PLANNING REPORT - Major Site and Building Plan Review and CUPs

RE: Sunfish Lake – 1 Grieve Glen Lane – Site and Building Plan Review / CUPs

Re: *Site and Building Plan Review
1 Grieve Glen Lane
City of Sunfish Lake, MN
WSB Project No. 1011-99*

REVISÉD EXHIBIT A

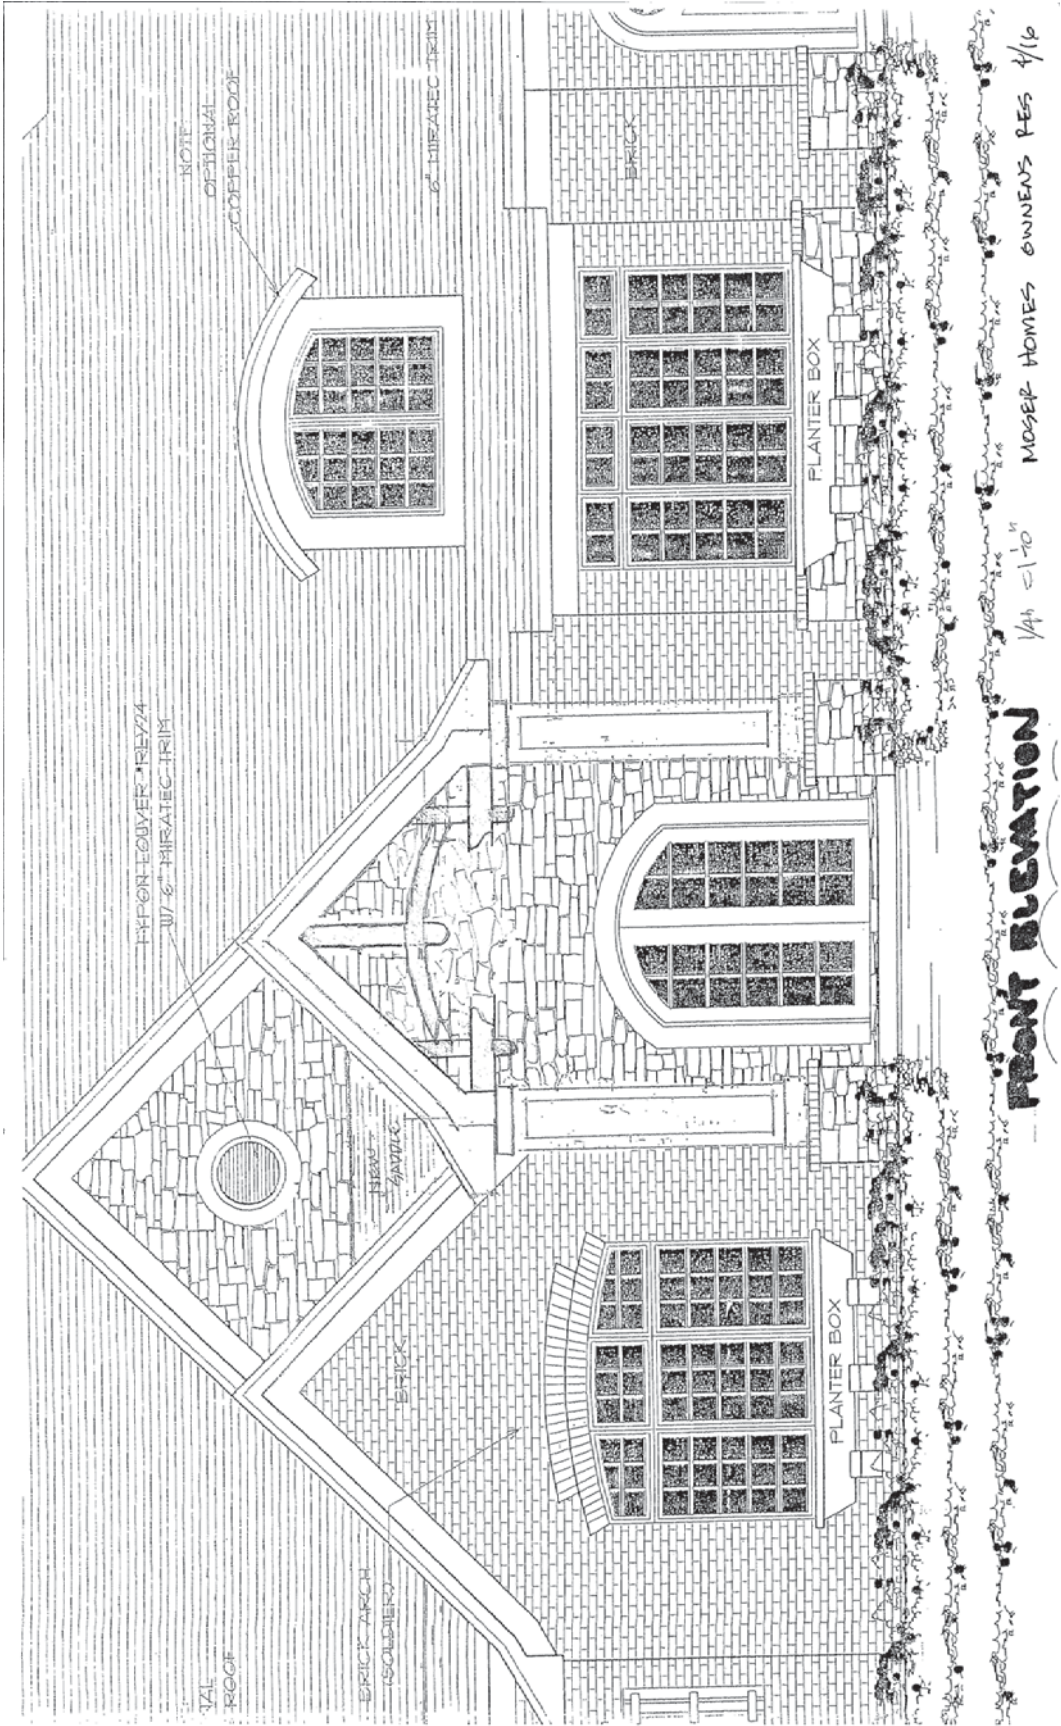
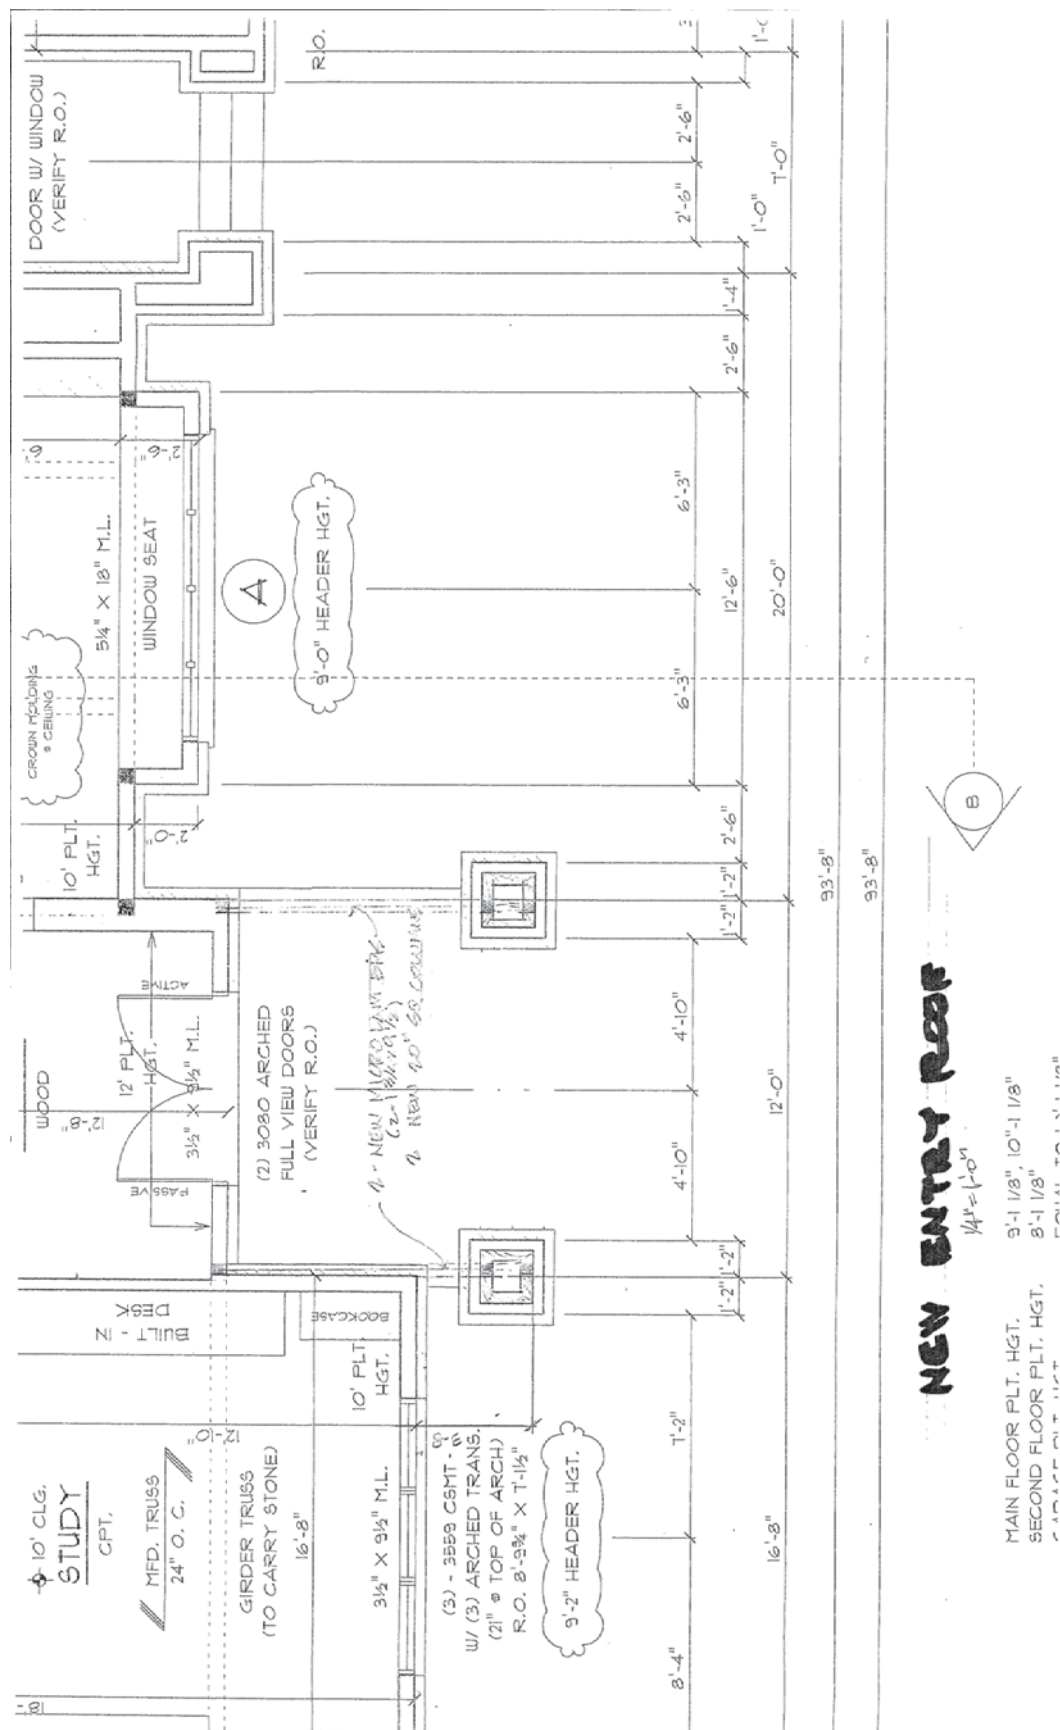
2. Currently the finished floor elevation of the garage is 875.5 feet, which will need to be adjusted up .72 feet to 876.2 feet to meet high water elevation requirements.

The applicant's proposed site grading plan shows a proposed garage FFE of 875.5 but the "Proposed Elevations" list an elevation of 881.0, please clarify this discrepancy. The site grading plan shows positive drainage away from the proposed garage foundation; however there is a significant amount of drainage directed across the proposed drive in front of the garage location with a rather steep (10%) grade coming down the drive from the north. We recommend a possible solution of raising the garage floor elevation from the 875.5 in order to soften the steep driveway grade and possibly reduce the velocity of overland flow coming off of the new pavement.

The proposed, temporary stockpile location(s) need to be at locations that are within 50 feet of a driving surface for the Sunfish Lake building ordinances, please indicate these locations on the grading plan. The applicant will need to construct and maintain a rock construction entrance of approximately 50 feet in length and 20-feet wide at a point where the contractor is entering the paved surface and leaving an exposed dirt area to minimize tracking of material off the project site. This must be shown on the plans.

Please consider utilizing riprap or other permanent erosion control devices where the overland flow from the driveway outlets to the east in order to prevent potential erosion control issues.

Please provide the area of land to be disturbed. A National Pollutant Discharge Elimination System NPDES Construction permit will be required if over an acre of land it to be disturbed.
